STAFF REPORT: APPEAL

APPEAL NO.: **A-1-HUM-96-58**

APPLICANT: **GARY JOHNSON**

PROJECT DESCRIPTION: **Development of a 1,245-square-foot, one bedroom single-family residence with an attached two-car garage with the living area above the garage.**

**EXHIBIT NO. 4**  
**APPLICATION NO.**  
 A-1-HUM-96-58  
**SITE PLAN**

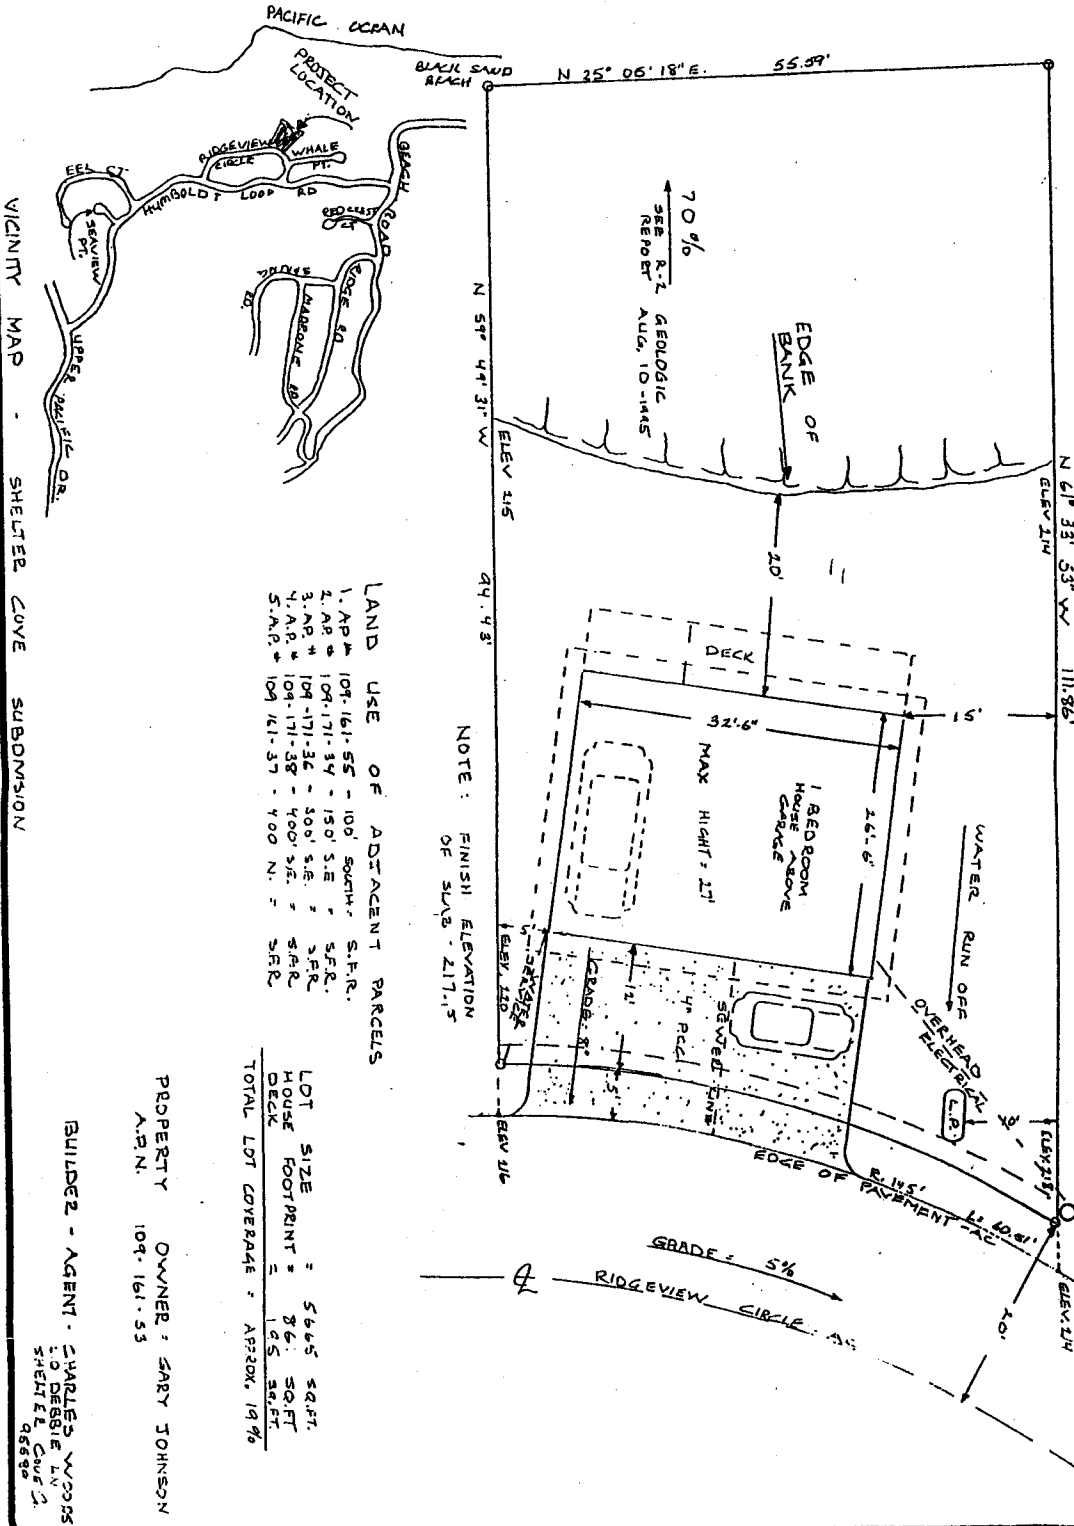
The appellants contend that siting the house 20 feet from the bluff edge as proposed will not maintain a bluff setback equivalent to the "area of demonstration" in an area of known high instability. As the appellants contend that the soil and geologic engineering investigation has not demonstrated that the development will assure the stability and structural integrity of the project, the appellants contend the proposed development is inconsistent with Policy 3.28B(2) of the South Coast Area Plan which requires that new development not be located in the area of demonstration unless a soil and geologic engineering investigation report demonstrates that development within the area of demonstration will assure the stability and structural integrity of the project for its expected economic life.

Figure 7.16. Site analysis: Shelter Cove area.

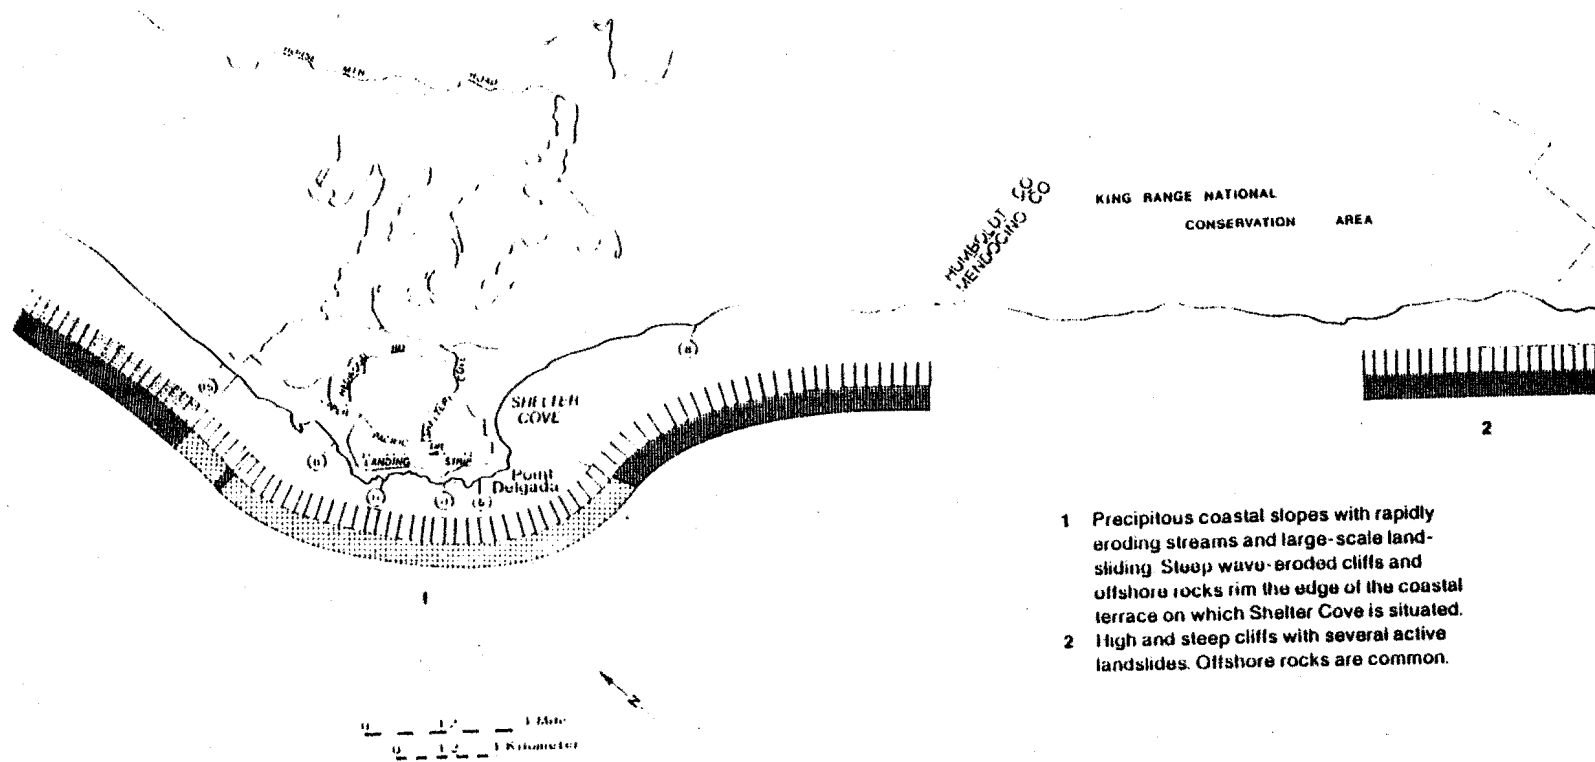
Another source of information about bluff retreat at the Shelter Cove area suggests that cliff retreat in the vicinity of the project site is very different than the rate of bluff retreat as whole at Shelter Cove. Exhibit 11 shows a map of the shoreline in the vicinity of Shelter Cove derived from a figure contained in Living with the California Coast, edited by Gary Griggs and Lauret Savoy, published by Duke University Press in 1985. The geologists who wrote Living with the California Coast examined existing data about shoreline erosion and developed a series of maps delineating hazardous or potentially hazardous areas and existing erosion rates. The map for the Shelter Cove area, shown in Exhibit 11, shows a series of erosion rates. Around the coastal terrace upon which the Landing Strip is shown, erosion rates of 0 inches per year are shown. Further up the shoreline, in the vicinity of the Johnson lot, much greater erosion rates are shown. The nearest erosion rate given to the south of the Johnson lot is 8 inches per year. The nearest erosion rate given to the north of the Johnson lot shows 15 inches per year. This information indicates there is variability in the shoreline erosion rates in the Shelter Cove area and suggests that shoreline erosion near the Johnson lot may be much higher than the minimal average erosion rates developed for Shelter Cove as a whole by others that are referred to in the Cooksley and Baird reports. Therefore, the lack of a shoreline erosion/cliff retreat rate specific to the Johnson lot calls into question the appropriateness of the 20-foot setback recommended in the Baird investigation for the Johnson lot.
